6673 Moorgate Road Kirkby
S278 Works

Road Safety Audit
Stage 1
Designer's Response

Report title:	6673 Moorgate Road Kirkby Road Safety Audit Stage 1 Designer's Response
Date:	18.09.2026
Document reference and revision:	6673-JPG-XX-XX-RP-0641-S2-P01
Prepared by:	JPG Group Leeds
On behalf of:	Commercial Development Projects Ltd

MRKS278/CDP/1/1

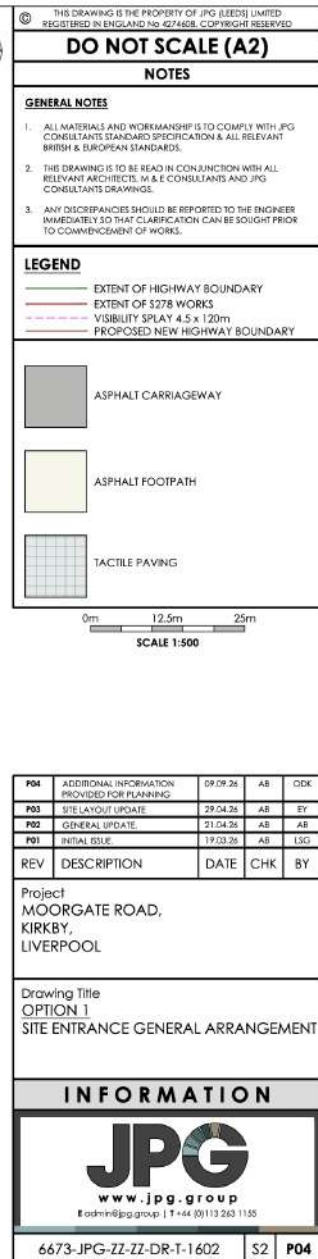
PROBLEM – 1

Location: HGV access

Summary: Lack of pedestrian crossing point

Although the proposals indicate dropped crossing points across the access road parallel to Moorgate Road, across the car-only access, and across the link road, no corresponding crossing point has been provided across the HGV access. The proposed footway continues along both sides of the link road, indicating a desire line for pedestrians that could require them to cross the HGV access without a defined facility. This may result in pedestrians crossing without the benefit of dropped kerbs, increasing the risk of trip hazards and reducing awareness to drivers of a potential pedestrian crossing movement.

It is recommended that a crossing point be included across the HGV access.

RSA problem	RSA recommendation	Design Organisation response	Overseeing Organisation response	Agreed RSA action
1. Although the proposals indicate dropped crossing points across the access road parallel to Moorgate Road, across the car-only access, and across the link road, no corresponding crossing point has been provided across the HGV access. The proposed footway continues along both sides of the link road, indicating a desire line for pedestrians that could require them to cross the HGV access without a defined facility. This may result in pedestrians crossing without the benefit of dropped kerbs, increasing the risk of trip hazards and reducing awareness to drivers of a potential pedestrian crossing movement.	It is recommended that a crossing point be included across the HGV access.	Footway surfacing was incorrectly shown extending along both sides of the link road and into the HGV access on the General Arrangement provided to the RSA team (6673-JPG-ZZ-ZZ-DR-T-1602-S2-P04-Option_1-General_Arrangement).  The General Arrangement has been revised to show where the proposed footway provision will terminate and the alignment of the fenceline which will restrict pedestrian access along the northern side of the proposed link road. See drawing 6673-JPG-ZZ-ZZ-DR-T-1602-S2-P05-Option_1-General_Arrangement at Appendix B.  This therefore removes the need for a pedestrian crossing.
